**REQUEST FOR TENDER
RFT 2024-046-AC ADDENDUM #2**

Champlain Mailroom Conversion

July 15, 2024

FLOOR PLANS
RCP

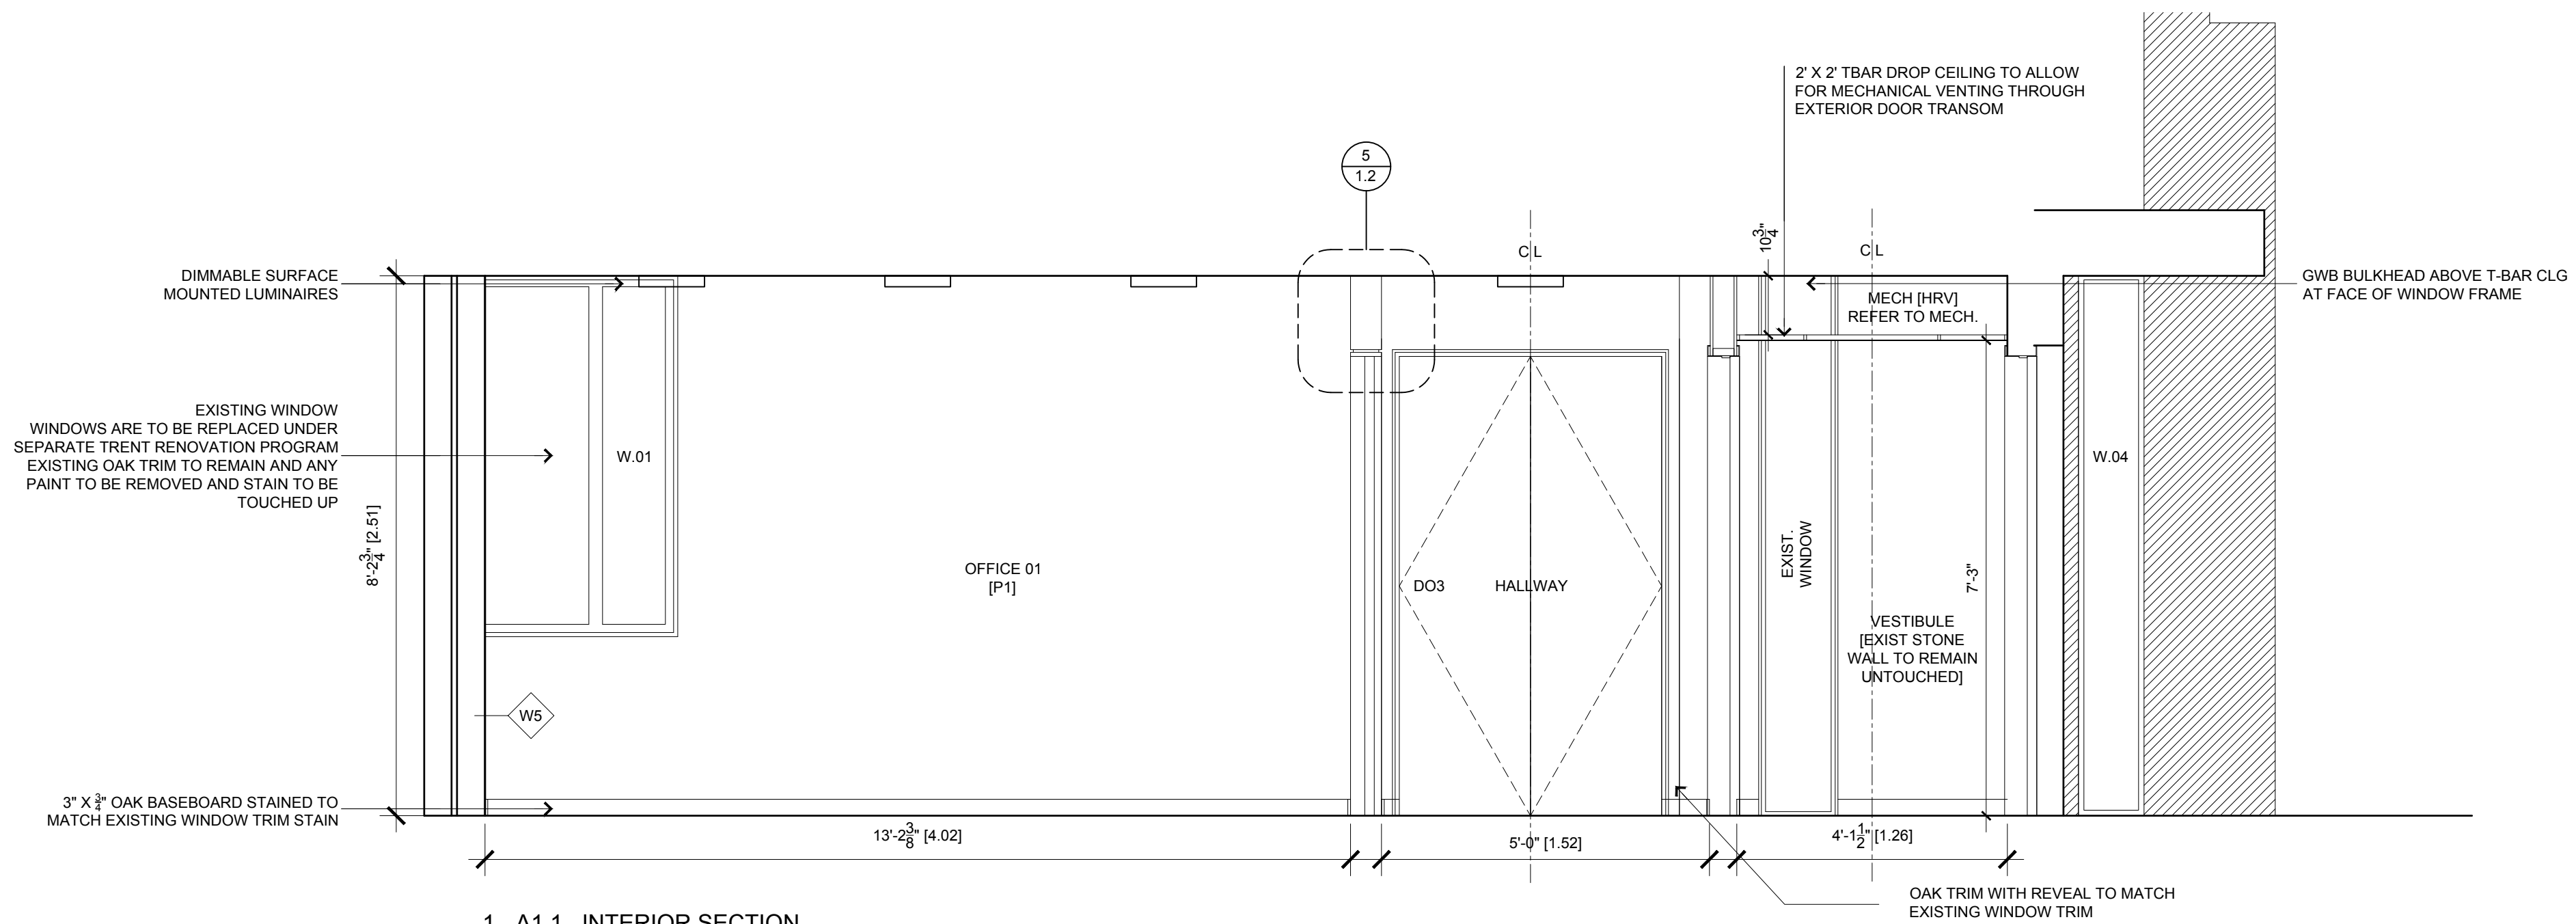
Question: Please provide a specification for the sound dampener material shown on 1-A1.0 for the interior walls of the planter bed.

Answer: *This is no longer required as the heat pump is now wall-mounted.*

5 - A1.2 OAK DOOR FRAME
D03, D04, D05
1"=1'

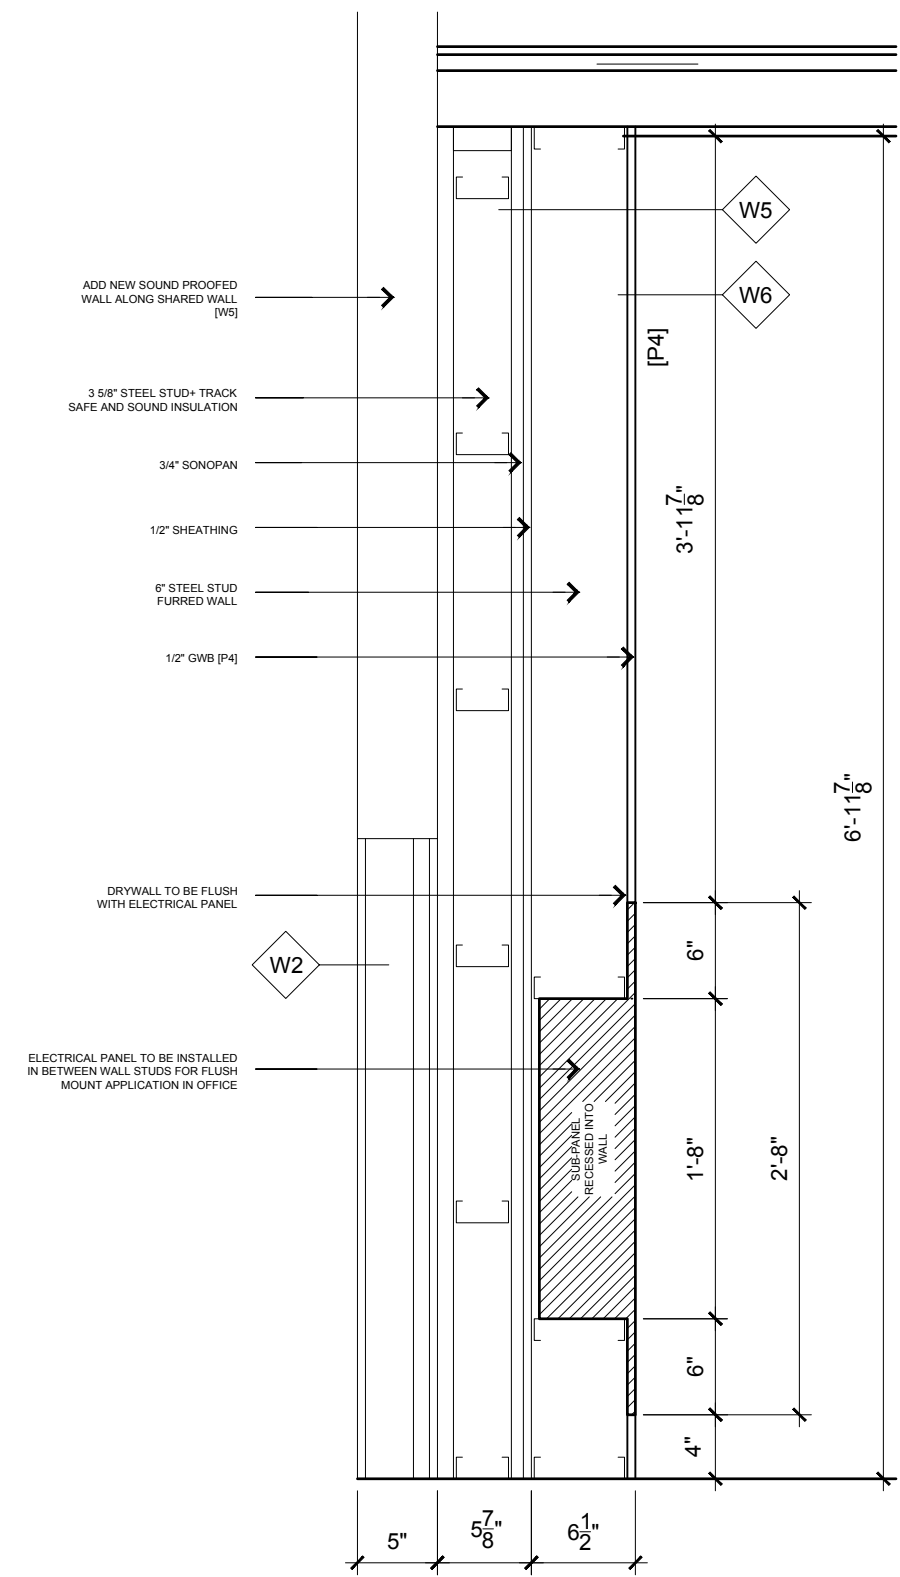
Question: The closet doors (D03) are listed on drawing F2 as 2 @ 30" x84", but the W3 wall containing the two doors only appears to be approximately 55" wide. Please clarify.

Answer: *Please see the revised finish schedule and drawings, revised to 2 - 24"x80" doors.*
